From: Anita Gardner
Sent: 23 October 2017 18:55
To: Planning.Responses
Subject: FW: Planning application Ancton Manor

Please scan against M/32/17/L and M/31/17/PL as correspondence between agent and historic building adviser

Job Title			
Client	Ancton Manor Dr Heather Beaumont		
Drawing Name	Plans & Elevations Proposed		
Drawing Status	Planning		
Drawn by	AF	Date	Mach 17
Checked by		Date	
Drawing Scale	1:100 at A2		
Drawing No	16905/ 02	Status	Revision
			A

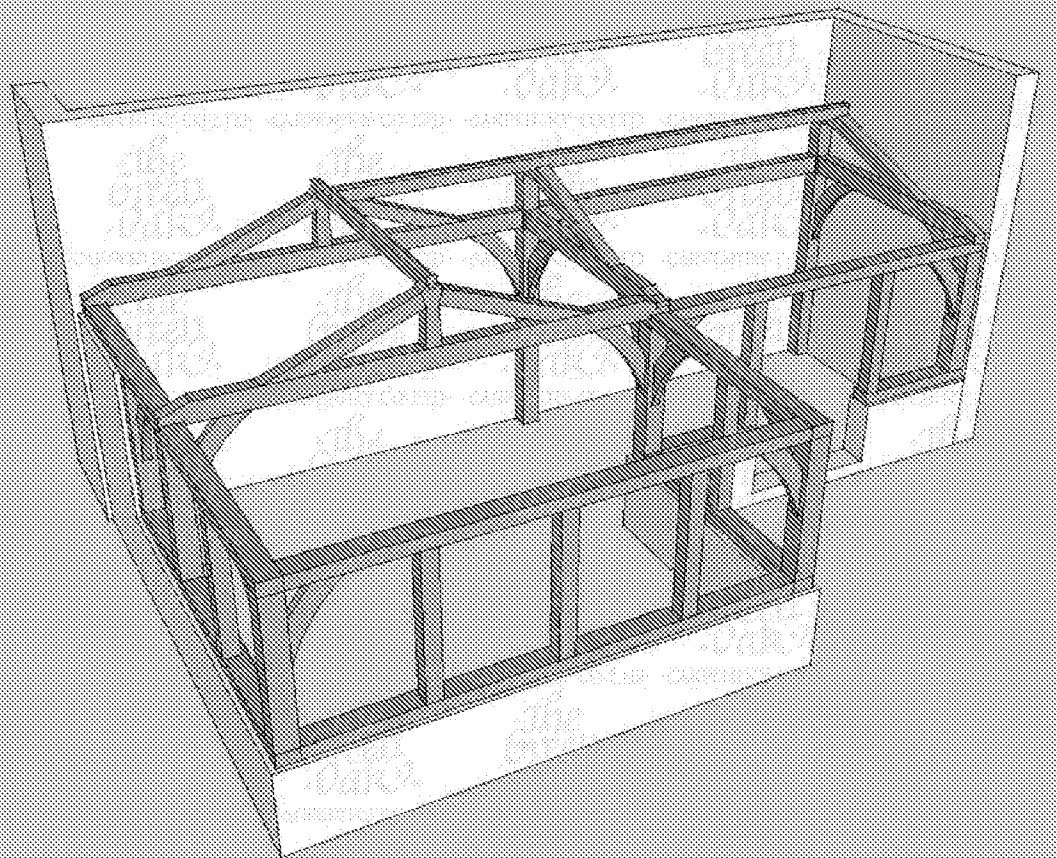
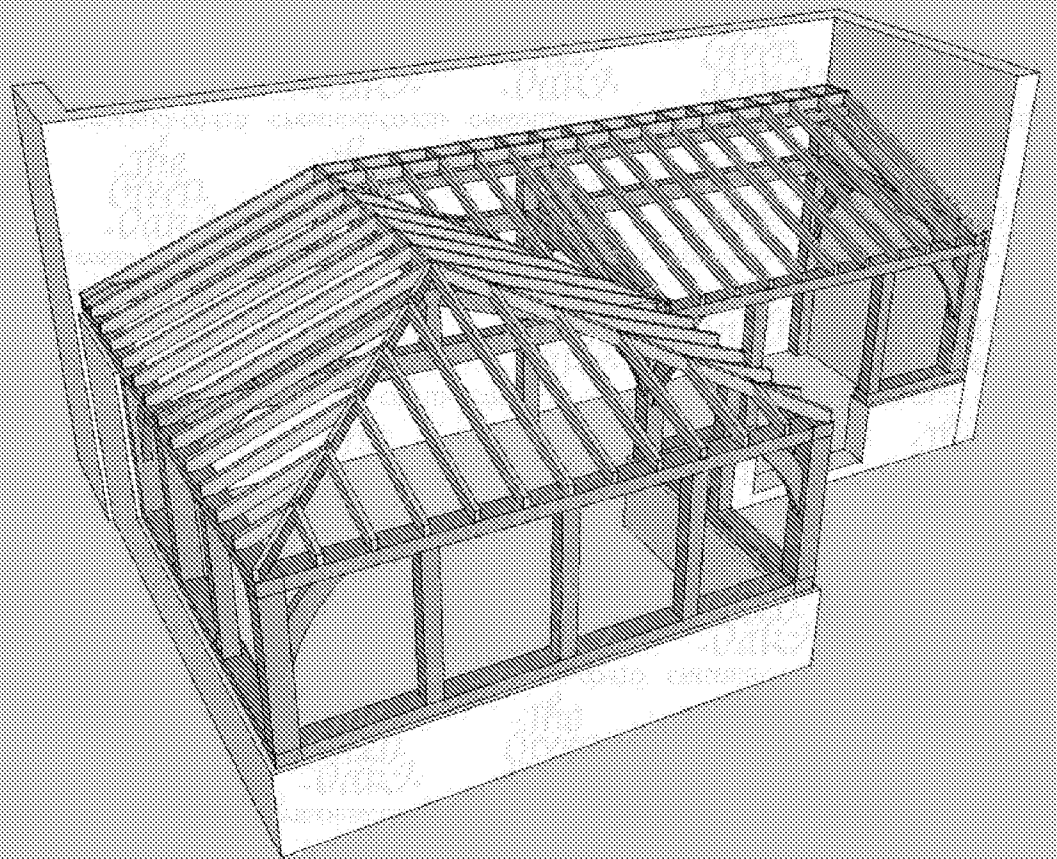
I now attach some visualisations which I have received this afternoon from the Green Oak Carpentry Company.

This allows a frame feel internally but with the pitched roof and joinery type windows. I think the stumbling block is going to be the cost of the joinery, but I would appreciate your comments, if you wouldn't mind? Do you think we could retain the more oak-frame windows I originally proposed? And no parapet? As this is a 17thC farmhouse, not Georgian?

Thank you for your drawings and apologies for the delay getting back to you. This seems a more sympathetic approach as long as the finished article does not appear too barn-like with the heavy timbers. Yes, I agree that the building without a parapet is more sympathetic.

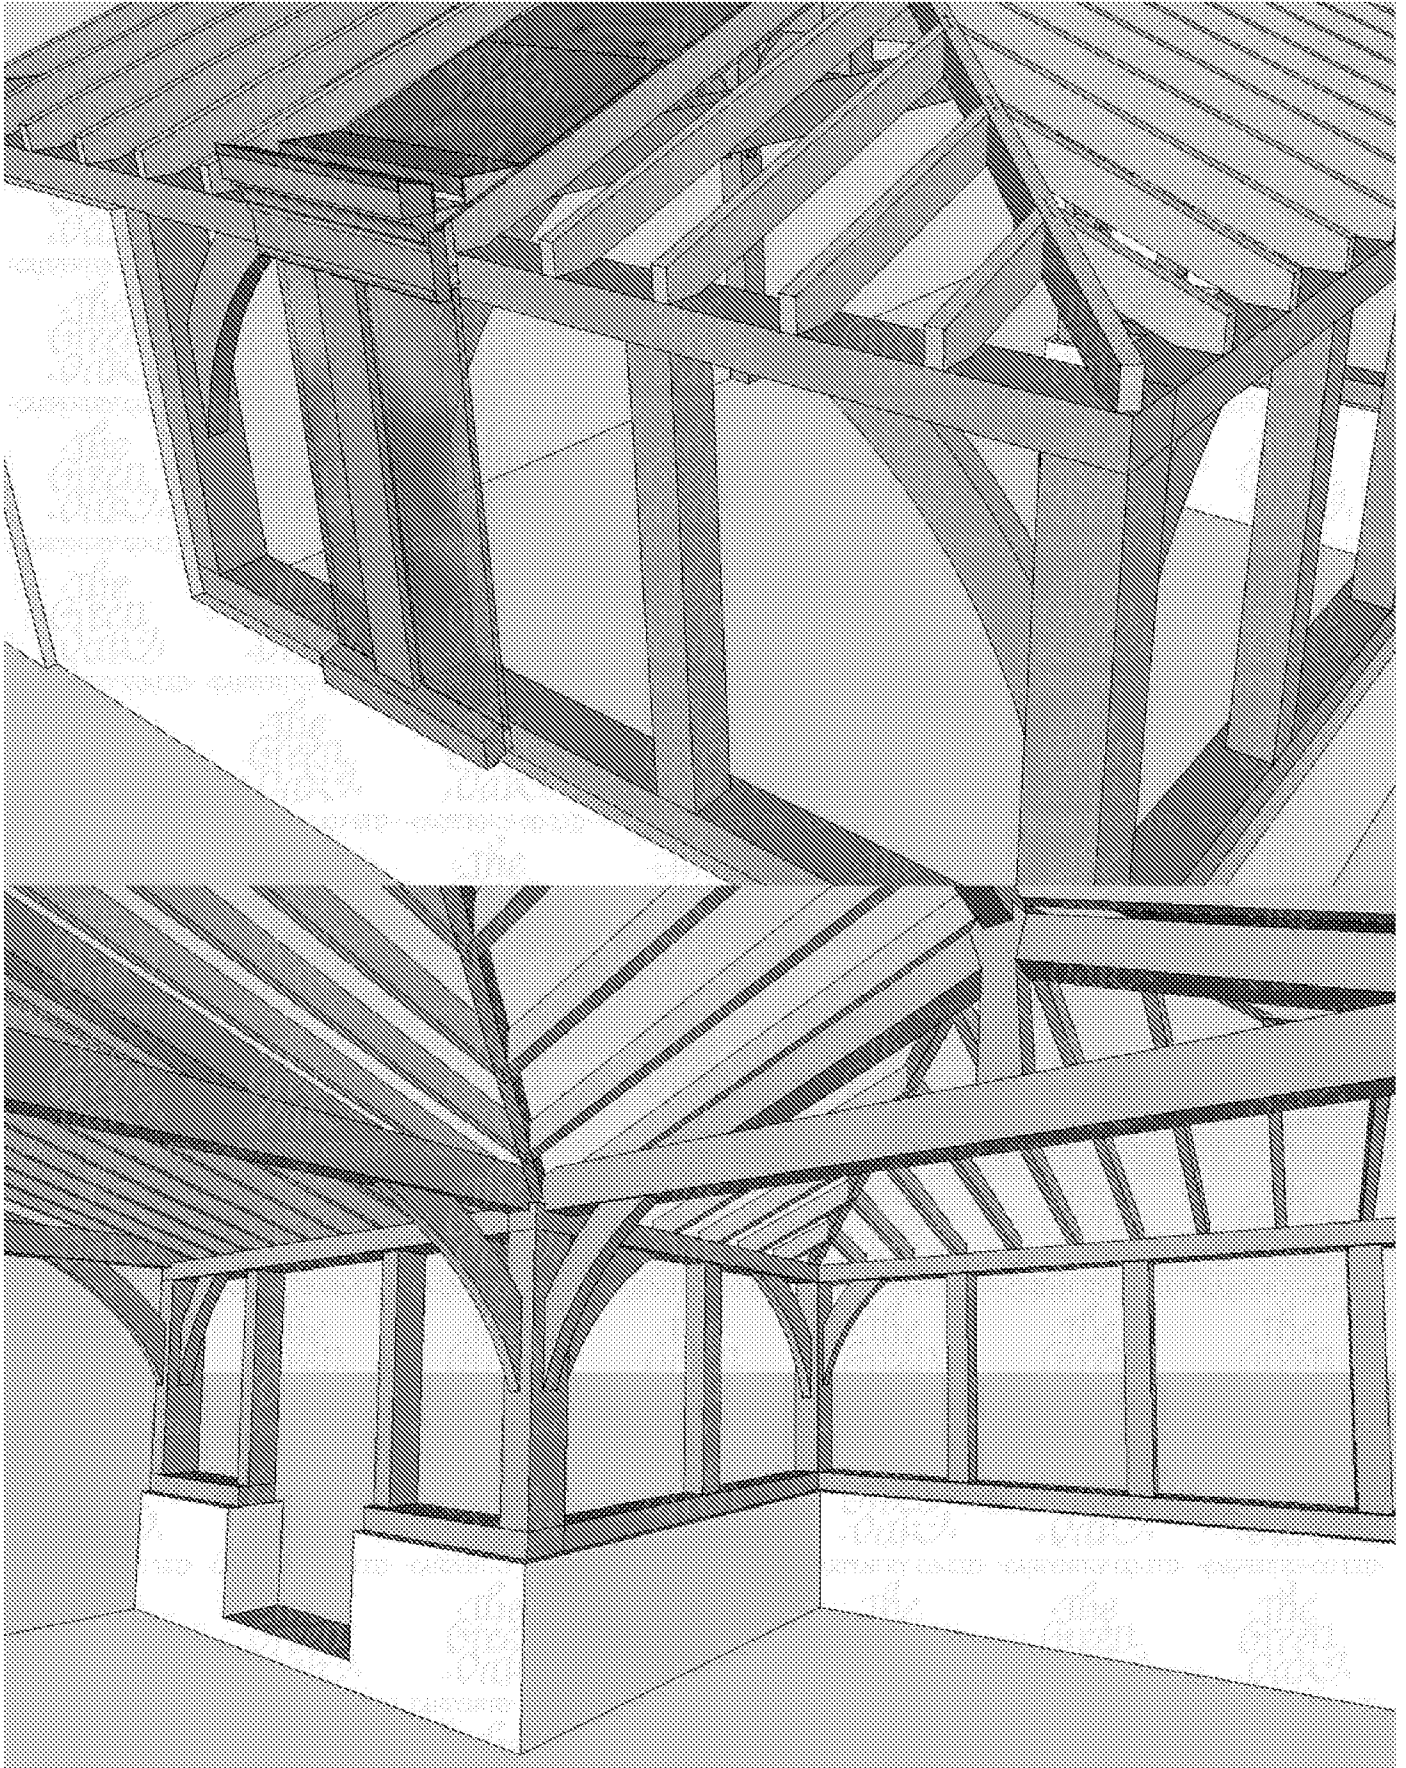
As discussed on the phone reservations remain regarding the use of a crown roof. Whilst we appreciate that they limit the impact of a full roof and provide a sense of vernacular form, they are a bit of a hybrid and very much a modern artifice. In this instance we believe it also introduces a little too much bulk and weight to the building.

Looking at this further we wonder whether the main part of the extension which projects furthest should be considered more as a separate element from the shallower addition. This could then be connected to the remainder of the building with a simpler leaded roof. This would break up the overall form, but also make it appear lighter.

I have attached two images. One showing how the main addition might appear (though smaller) and another showing how the flat roof could continue in front of the building without adding bulk at roof level.

I am not sure whether you feel this might work, but notwithstanding the designs here which are a little too grand perhaps, the principle should work.

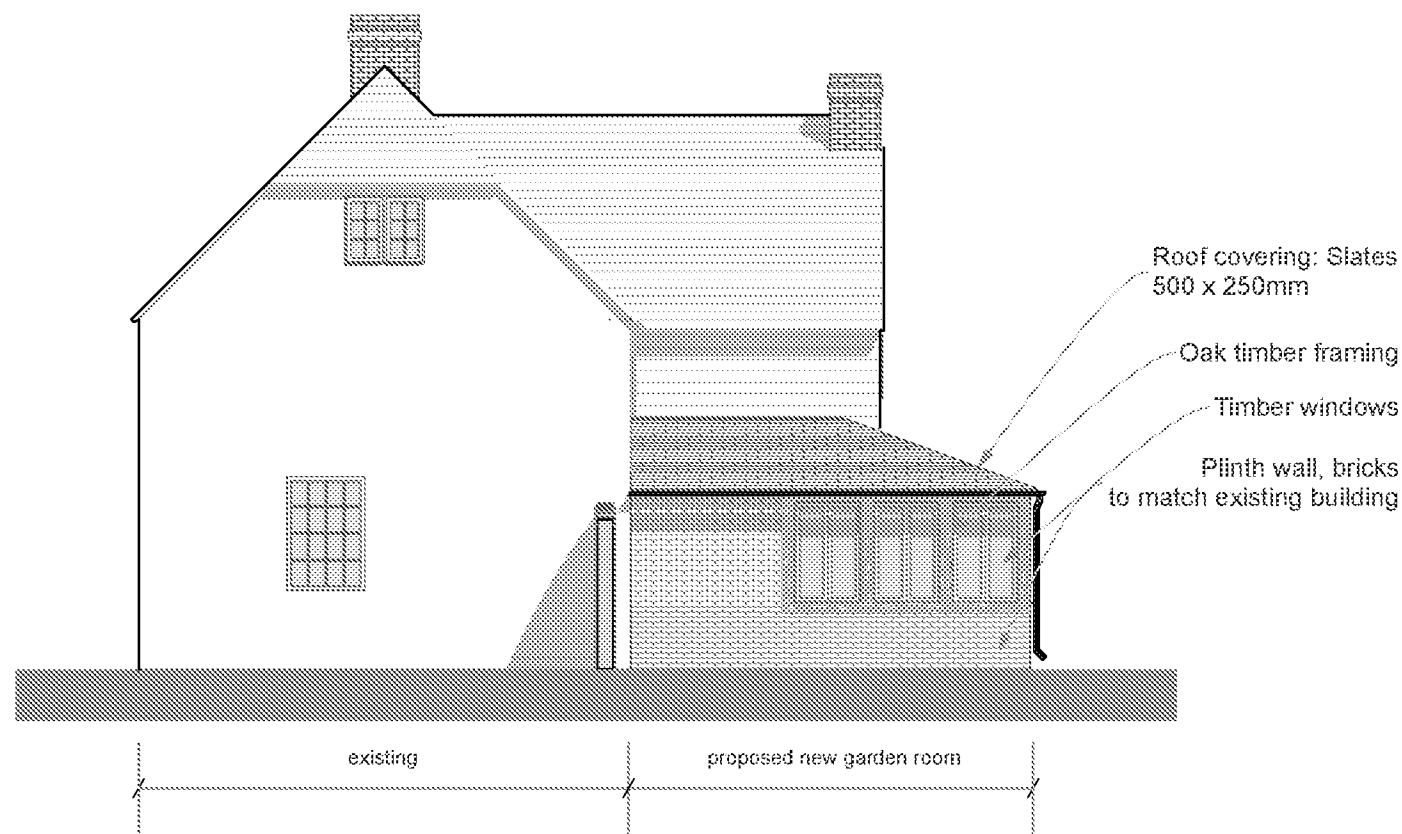
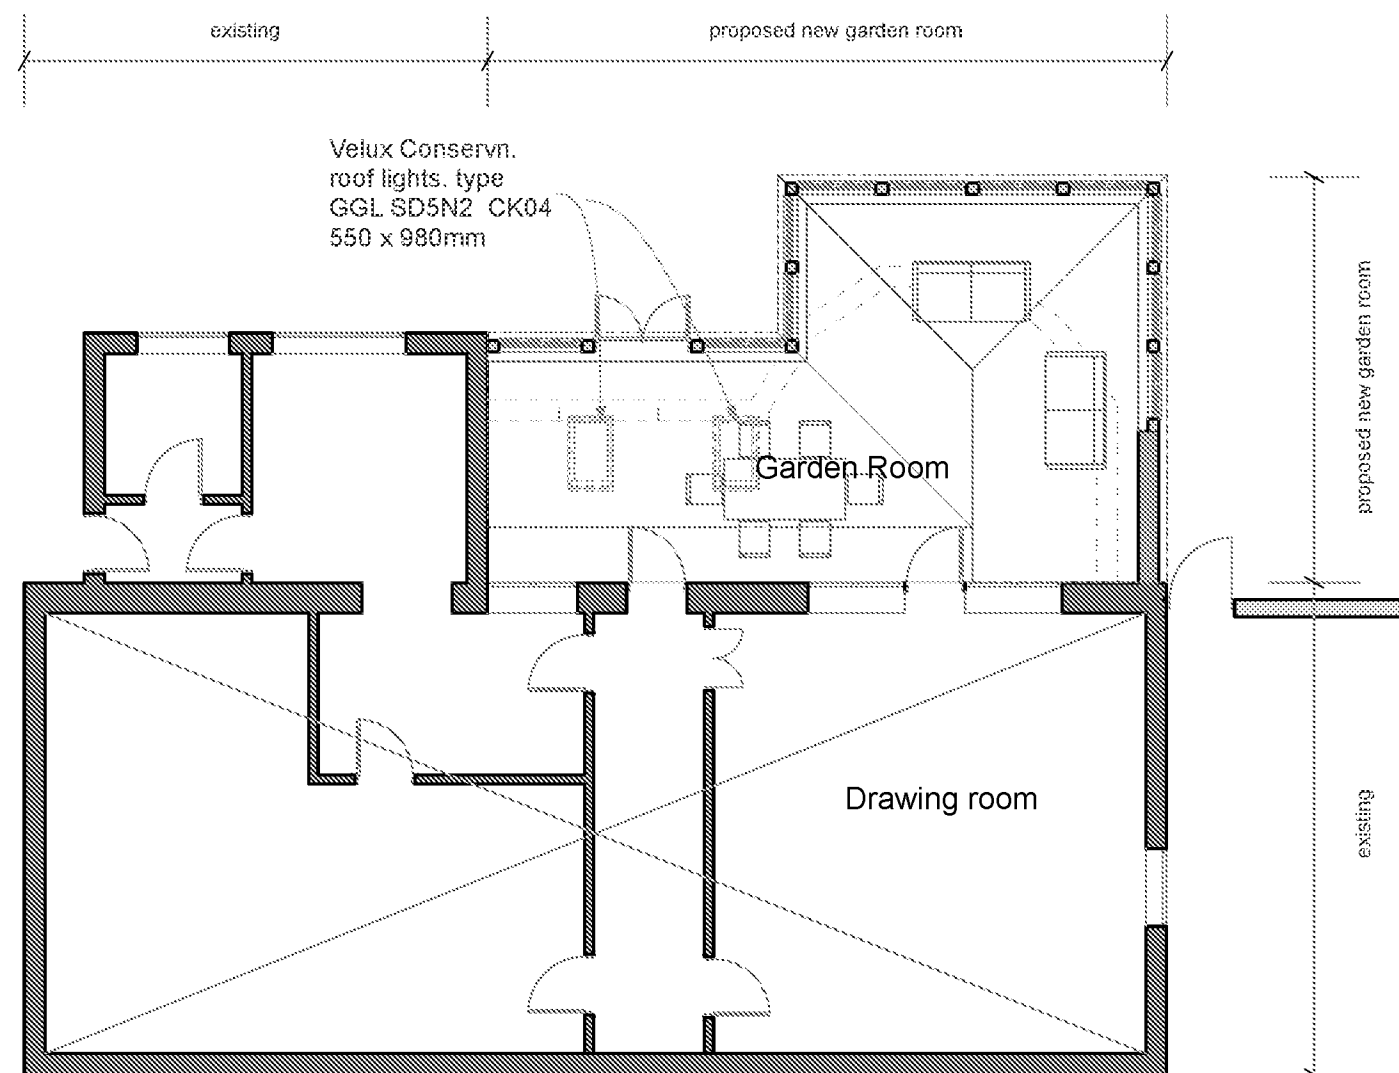
I attach also the drawing as submitted, which shows the omission of the parapet design, and the timber frame with suggested roof.

A Aug 17 Revised roof
